Addendum No. 003

**Subject: Rhawnhurst Elementary School- Additions and Renovations
SDP Contracts No. B-070, B-071, B-072 and B-073 of 2019/20**

**Location: Rhawnhurst Elementary School
7809 Castor Avenue
Philadelphia, Pennsylvania 19152**

This Addendum, dated March 30, 2021 shall modify and become part of the Contract Documents for the work of this project. Any items not mentioned herein, or affected by, shall be performed strictly in accordance with the original documents.

E0.2

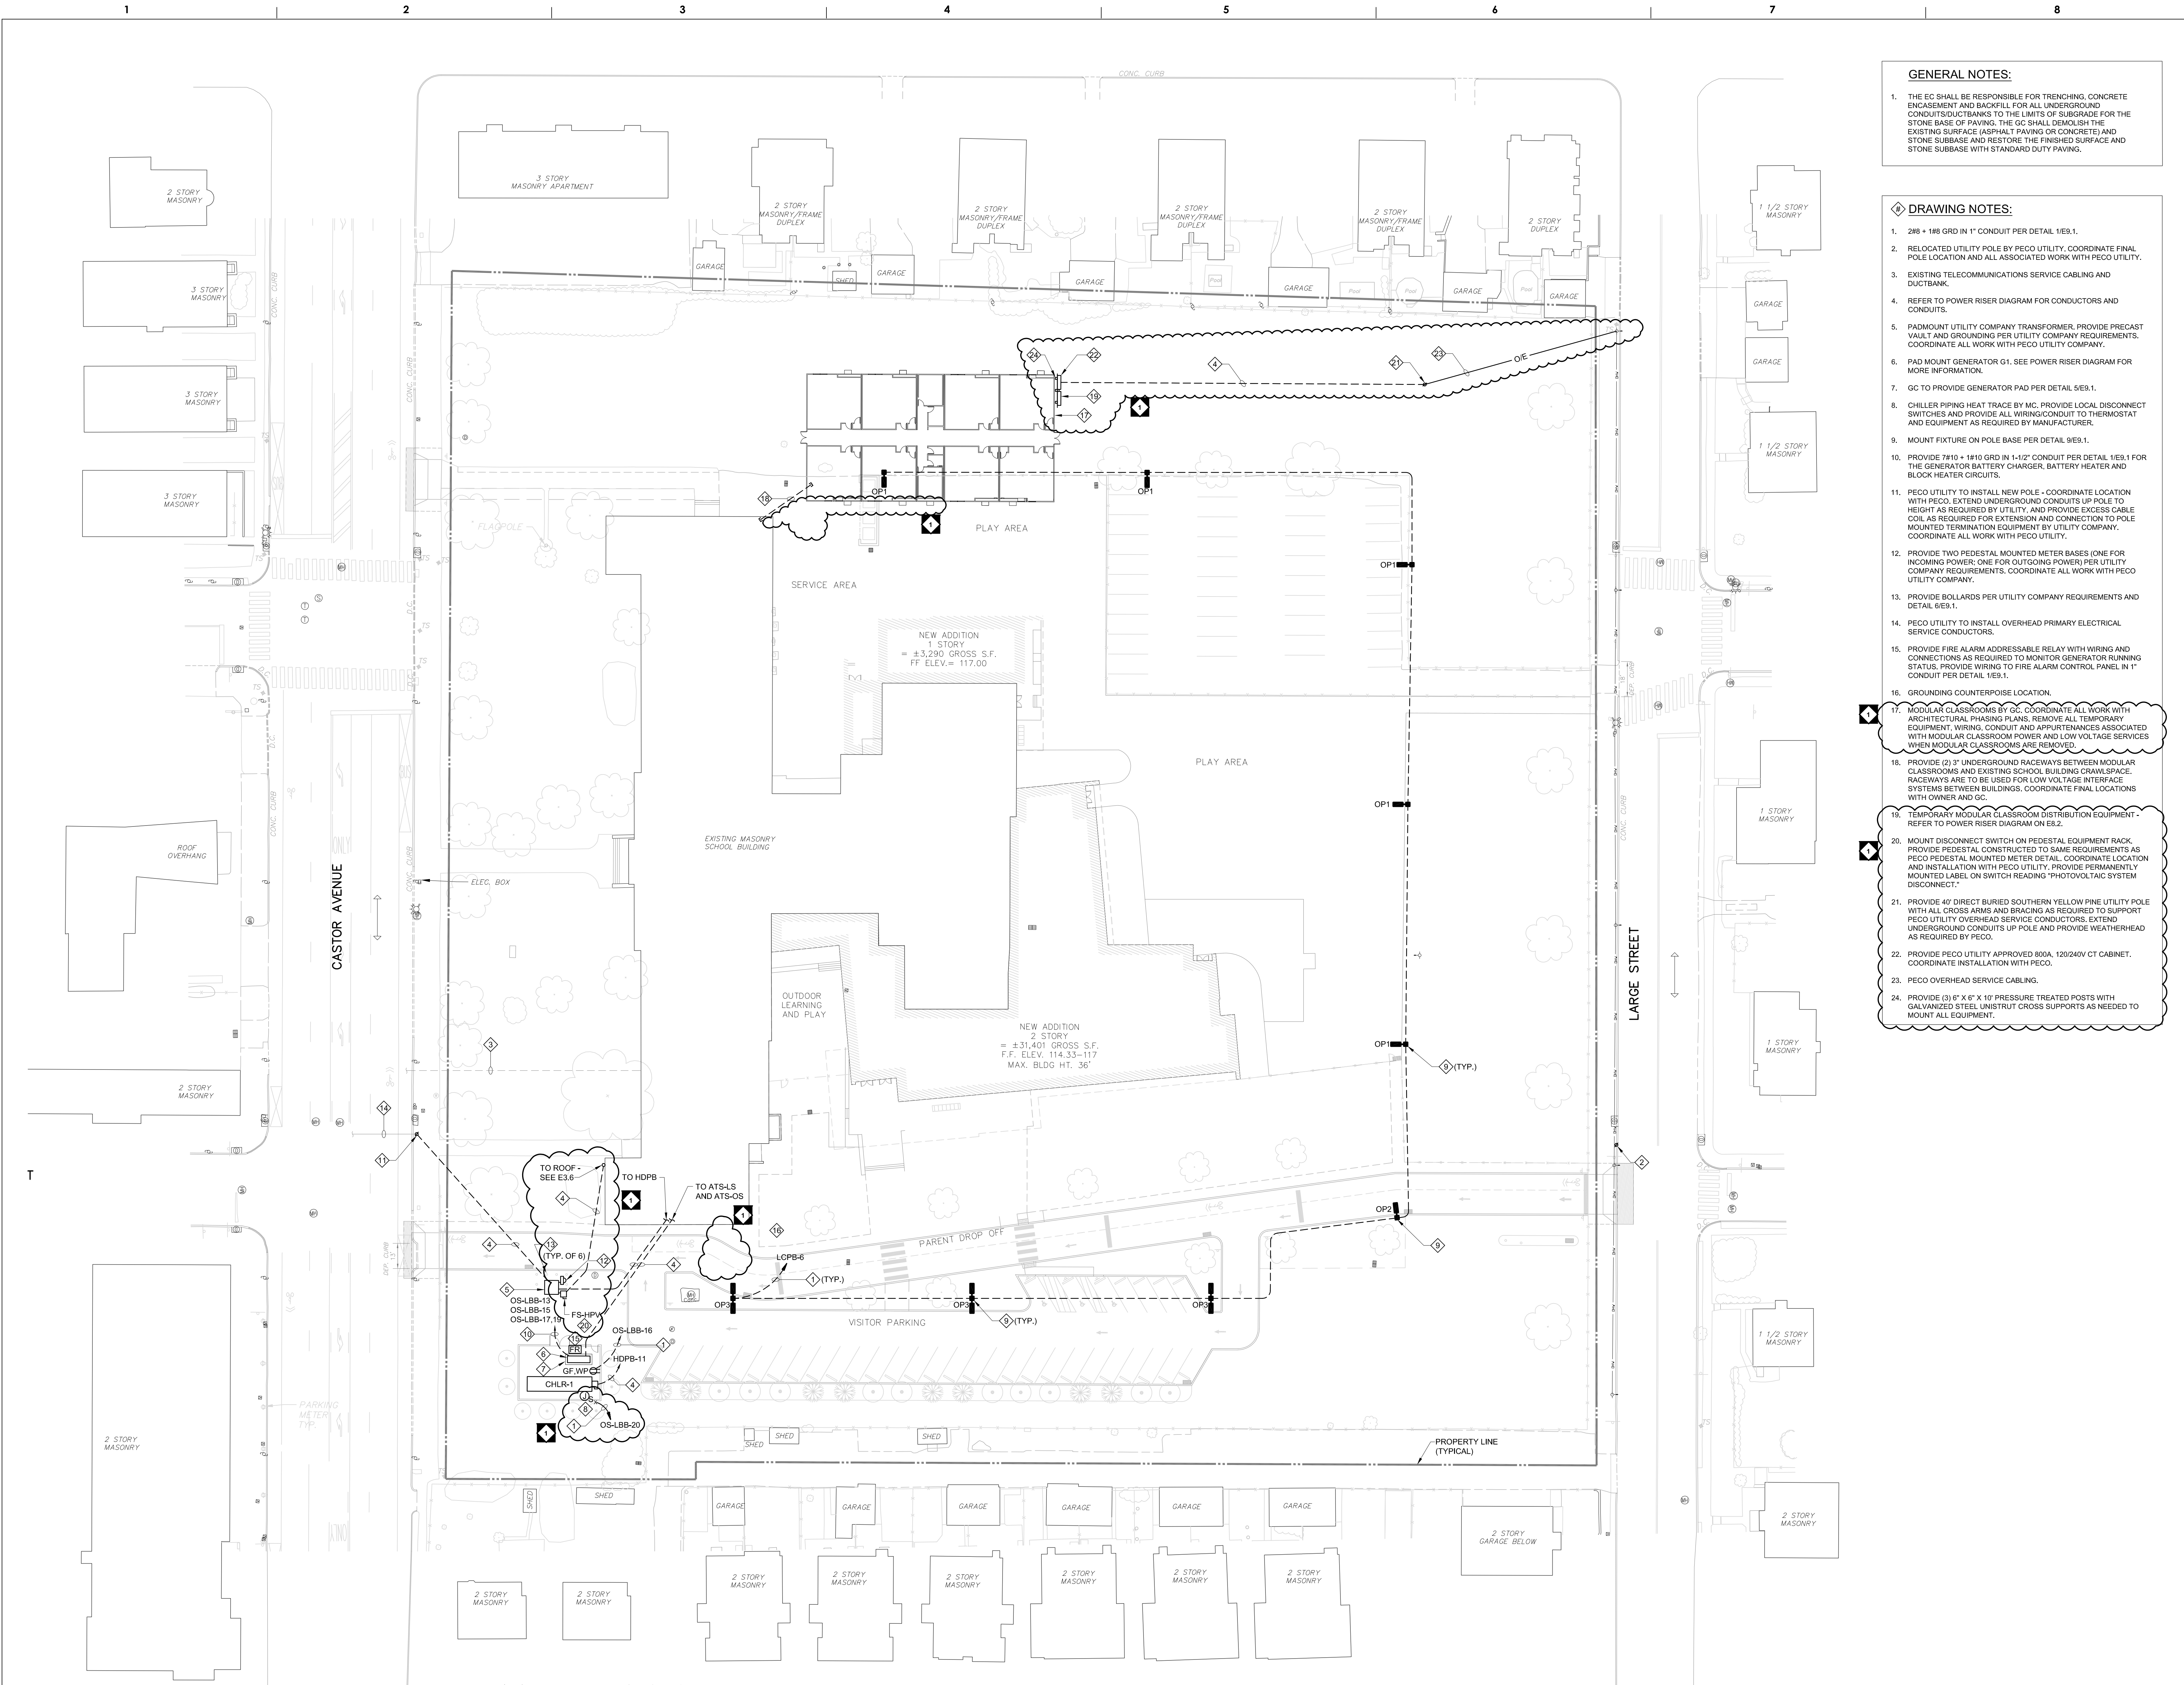
- 8. Please clarify which prime has the scope of providing the security bollards shown on drawing E0.2 note 13 - GC or EC?**

- 9. Drawing note 8 on drawing E0.2 does not appear to be shown in plan. Please confirm this note can be ignored.**

- 15. A fire alarm addressable relay is shown outdoors at the generator on drawing E0.2, but addressable relays are not rated for outdoors. Please confirm it is acceptable to locate this relay inside as close to the generator as possible.**

Answer: The EC shall provide bollards at the padmount transformer as shown on E0.2.

Answer: Chiller heat trace circuit with Note 8 reference added on Drawing E0.2. See ELECTRICAL DRAWINGS revisions above.

Answer: This is acceptable.

2 TEMPORARY MODULAR CLASSROOM POWER RISER DIAGRAM NO SCALE

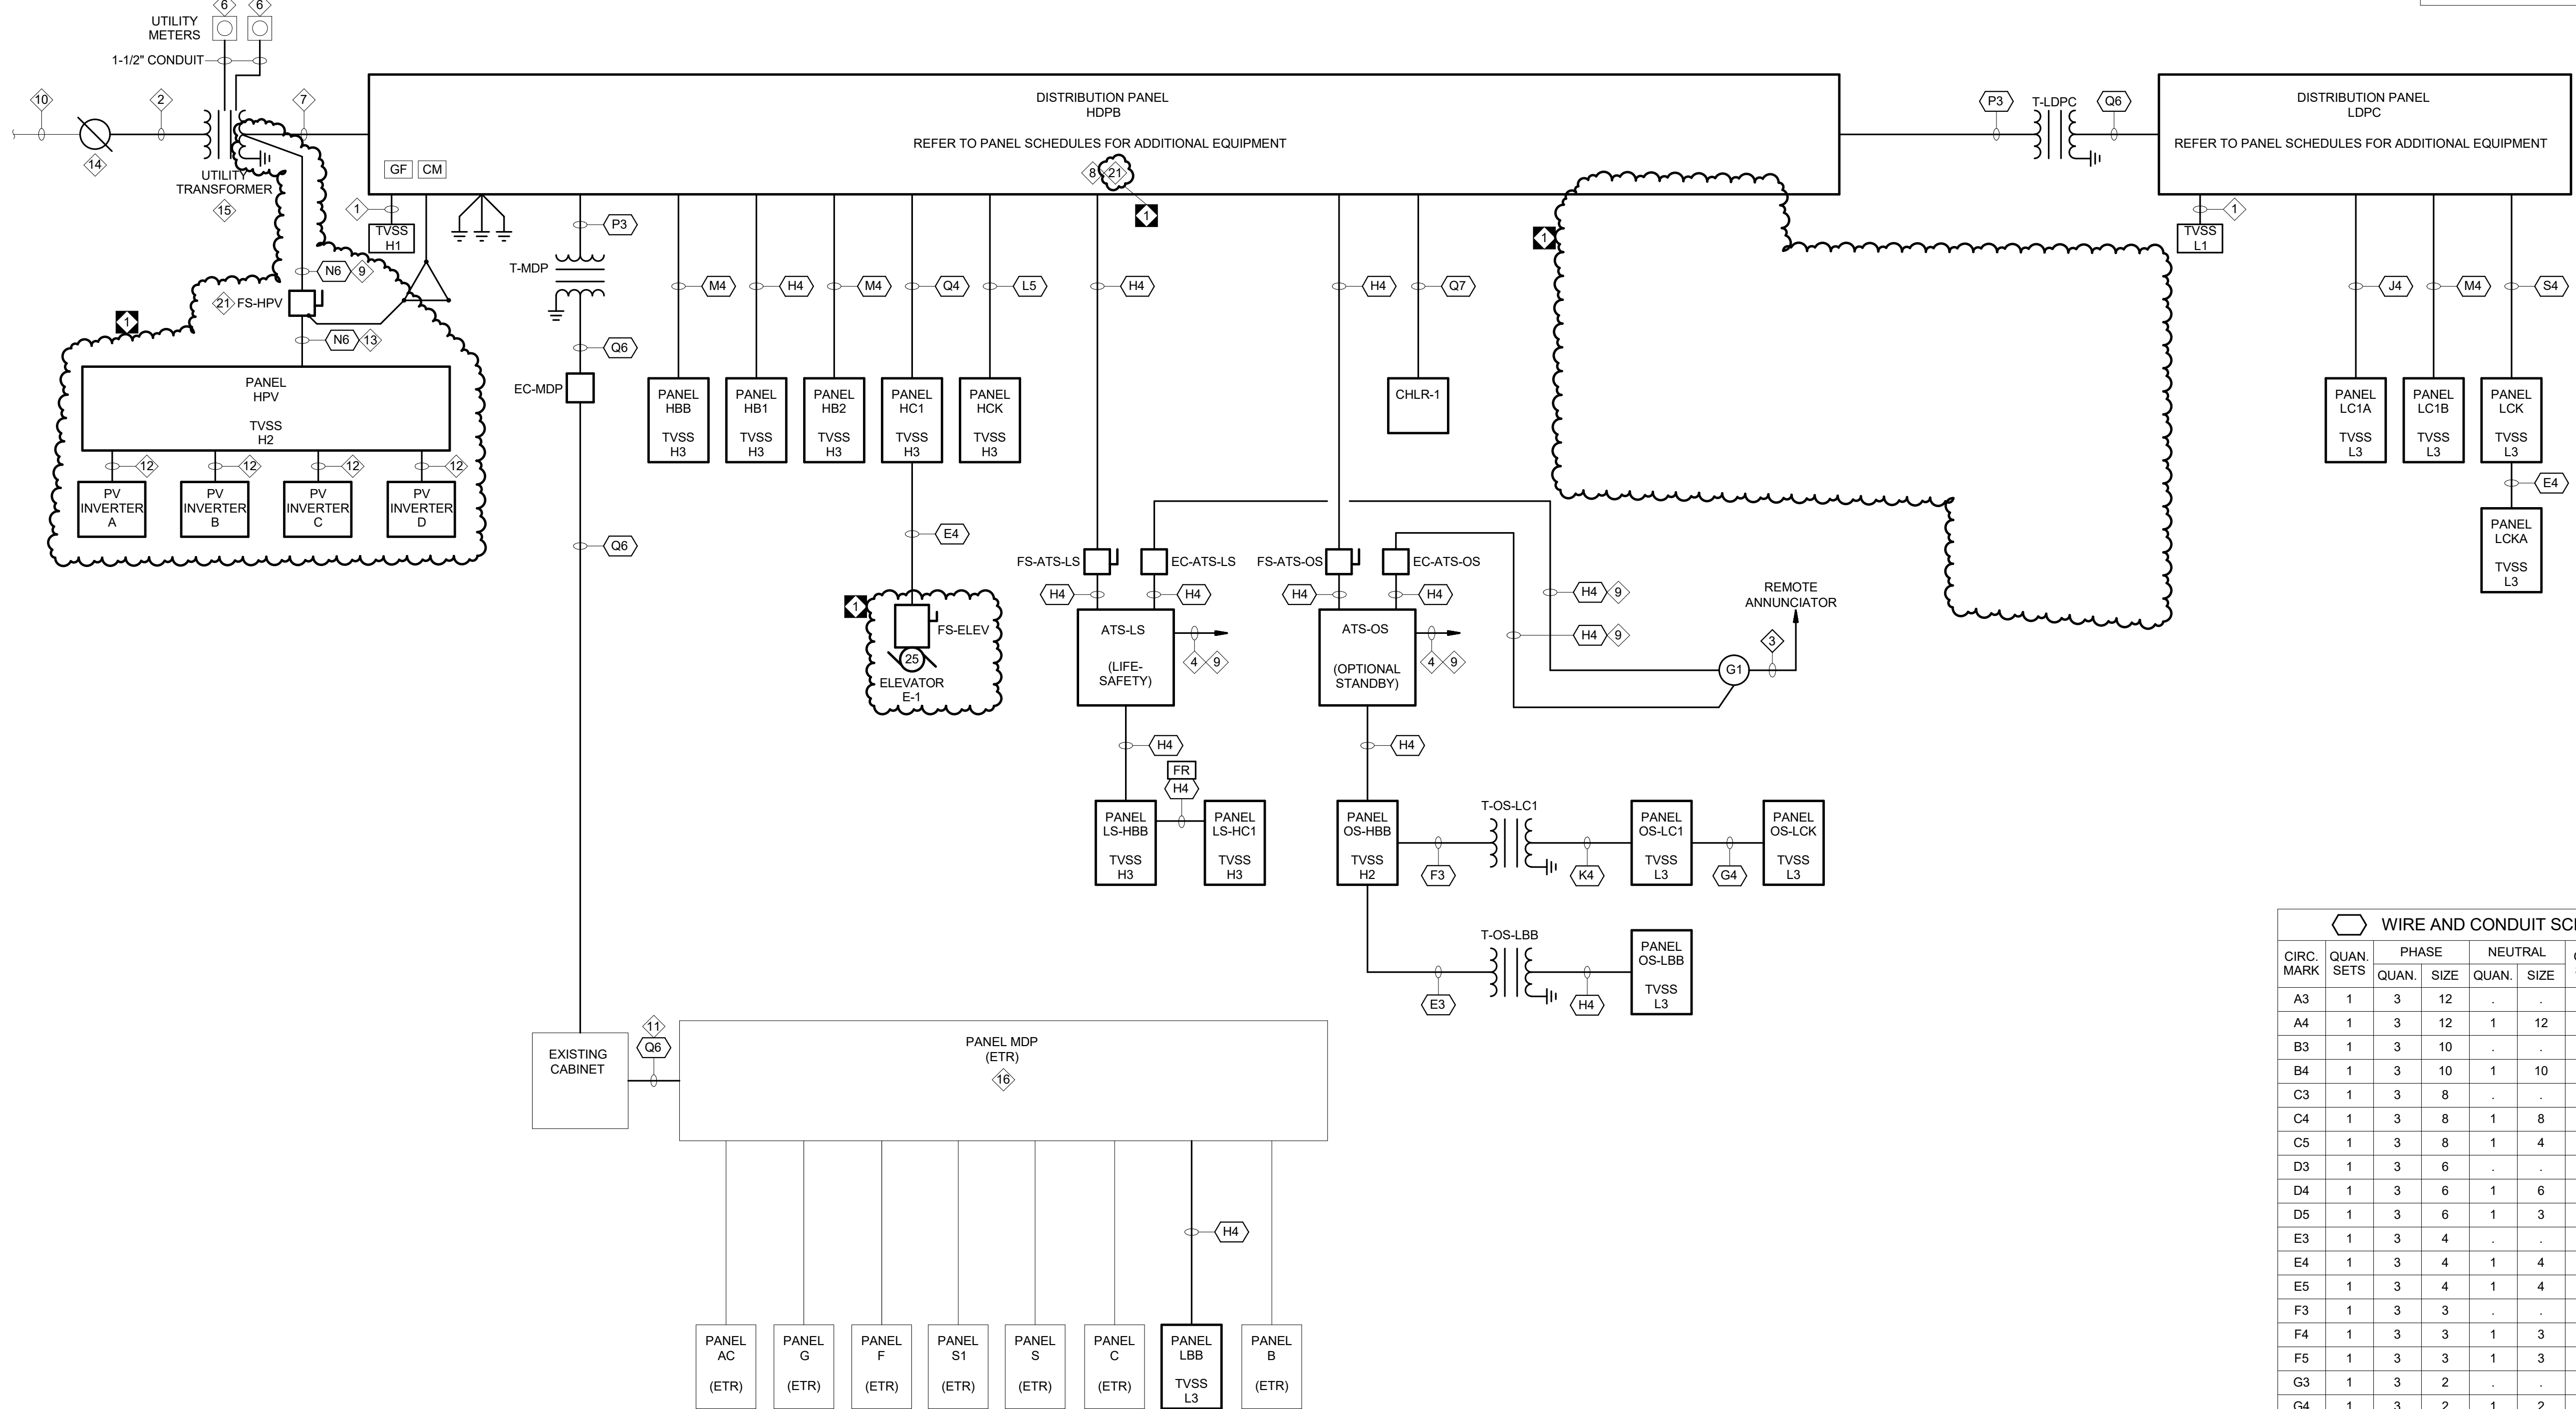
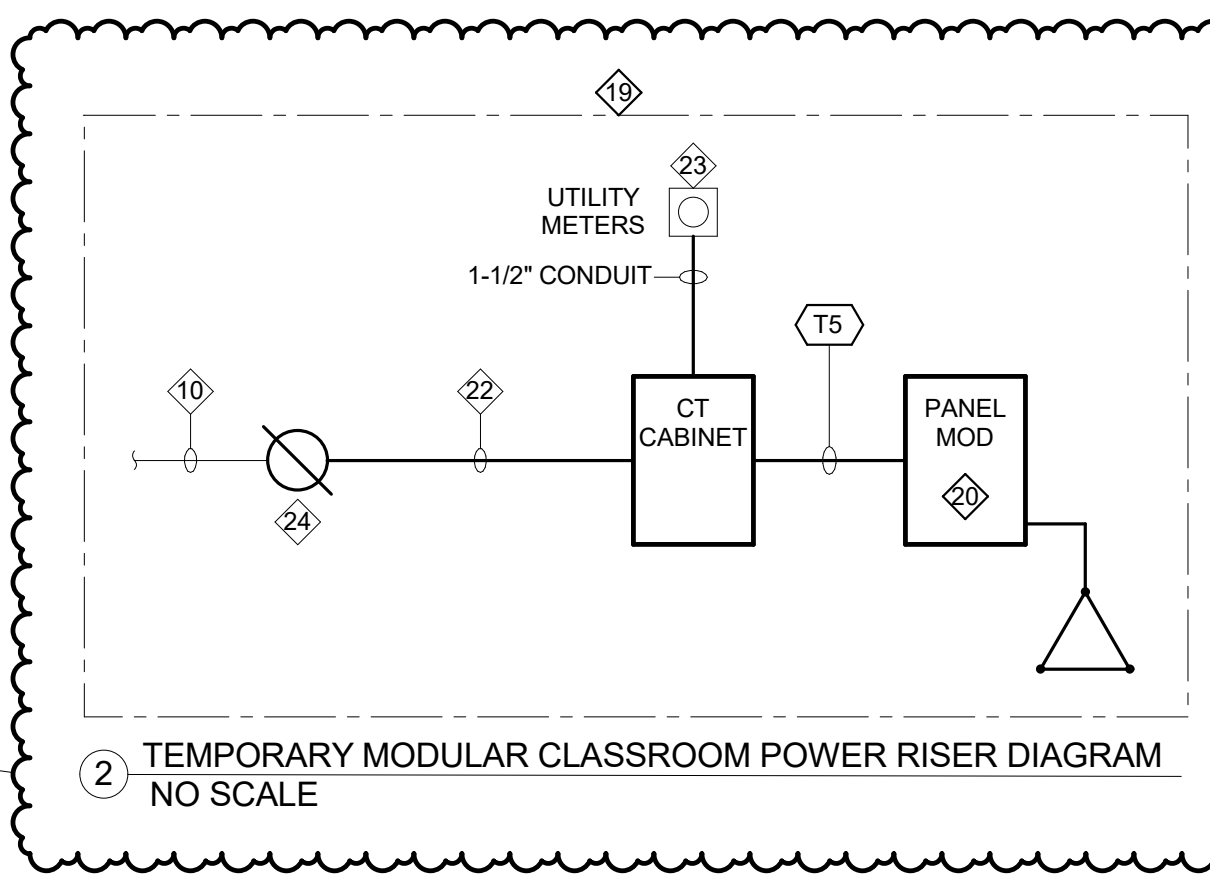
- 13. Specification section 262817 for the elevator disconnect is mentioned in note 5 on drawing E8.2 and mentioned in spec 260180, but this specification section has not been provided. Please provide this specification or clarify design. Please confirm the elevator disconnect should be a 100A-3P 480V fused safety switch in a NEMA 1 enclosure with 70A fuses.**

Answer: Specification 262817 elevator disconnect switch is not applicable. Please provide a 3P.100A, 480V fused disconnect switch with auxiliary contact. Assume 70A
